REPORT
of the joint World Heritage Centre/ICOMOS
Advisory mission
to the World Heritage property 'Historic Centre of Prague' (Czechia)
11-12 December 2024

ICOMOS
international council on monuments and sites

Fig. 1 The listed ensemble of Vyšehrad Railway Bridge (after NHI, slide 4, with additions).

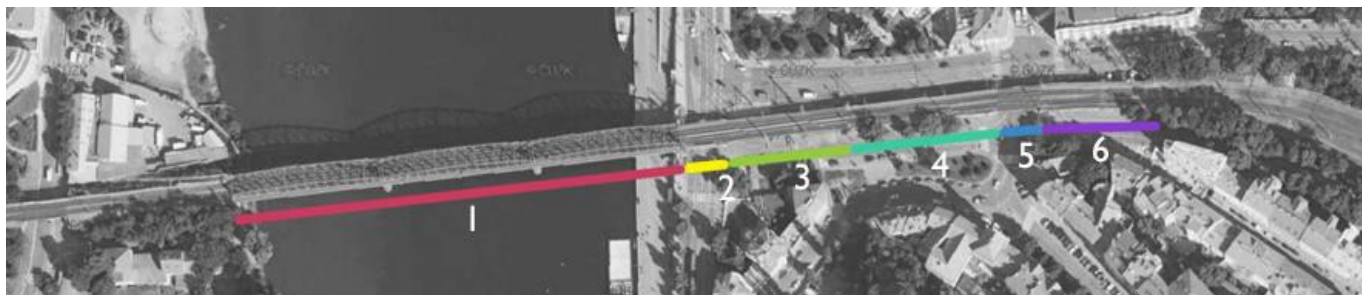
- In 1994, the bridge over Vyšehradská Street (Fig. 1, Section 5) was replaced with a modern welded steel chamber structure.
- In 1997-8, *'the steel structures of the Výtoň foreground were comprehensively reconstructed. As part of the reconstruction, the longitudinal trusses and the lower chords of the full-wall main beam were reinforced'*.

Fig. 4 Decaying paint layers on the steelwork of the bridge (Paul Drury, 11 December 2024).

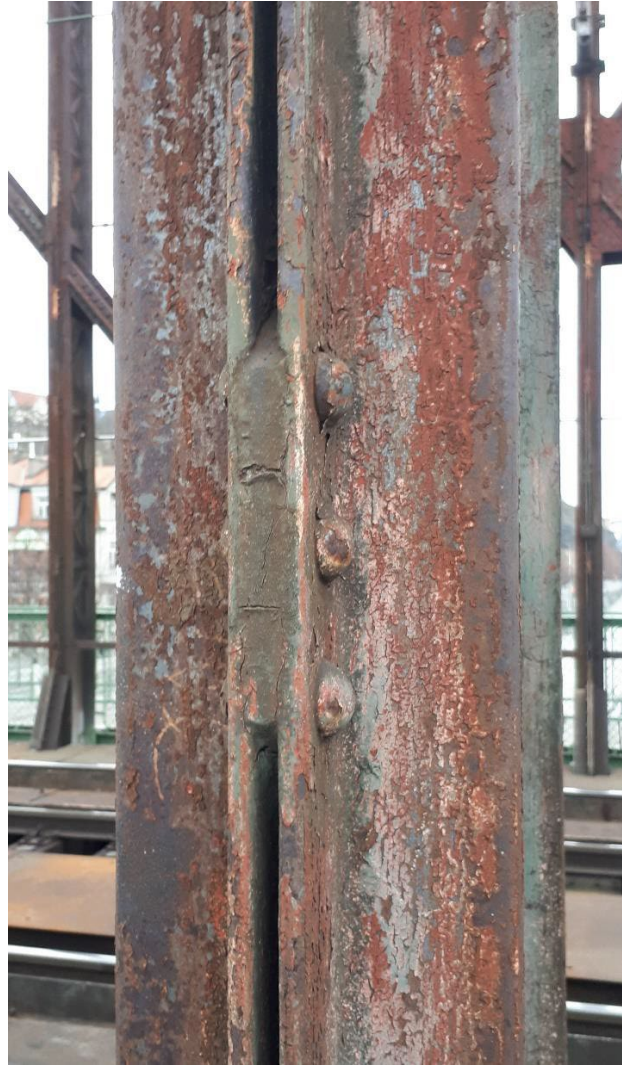
The steel bridge across the river now presents in distant views as being reddish brown in colour, a combination of rust and the remaining areas of multiple coats of dark red paint, probably rich in red lead oxide. Subject to technical investigation, this appears to have been the original finish. Painting was neglected after World War II, although there are superficial traces of a grey anti-corrosion finish applied over the dark red layers (Fig. 4).¹⁵
